**Appendix A. Individual Evaluations of 30 Peak Discharges from
28 Extraordinary Floods in the United States**

Seco Creek near D'Hanis, Texas

Review of peak discharge for the flood of May 31, 1935

Figure A191. Rating curves for Eel River at Scotia, California in 1940, 1955, and 1964 with pre-1950 measurements indicated in red. Note that including the highest and third highest measurements from 1940 would pull the 1955 and 1964 ratings to the left.

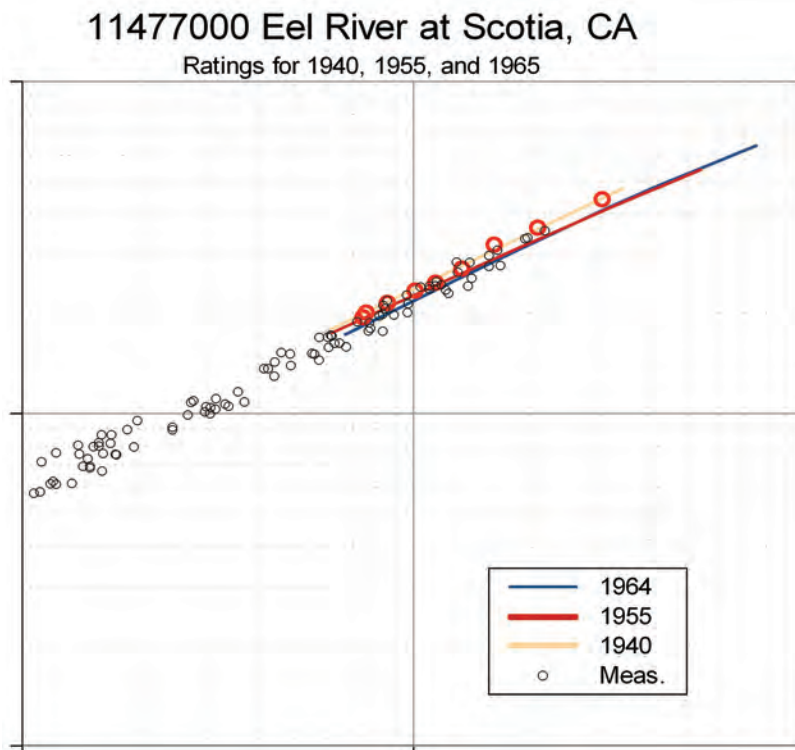
A review of all high-water measurements shows that 1940 measurements 171 and 172 are indeed the highest and third highest measurements available. However, measurements made in 1953, 1956, and 1963 in the range of 193,000 to 217,000 ft³/s show stages about 2 ft below those that would be expected from the 1940 measurements. Measurement 173 (161,000 ft³/s) made in 1940 has a stage 1.25 ft higher than measurement 360 (164,000 ft³/s) made in 1955. In fact, the 1940 measurements, for whatever reason, define the left-most measurements in the cloud of all high measurements. Stage versus width and stage versus velocity plots show that the 1940 measurements consistently define a slightly different relation than most of the other high measurements. However, nearly all the more recent high measurements were obtained with optical current meters, and these data were converted to mean velocity.
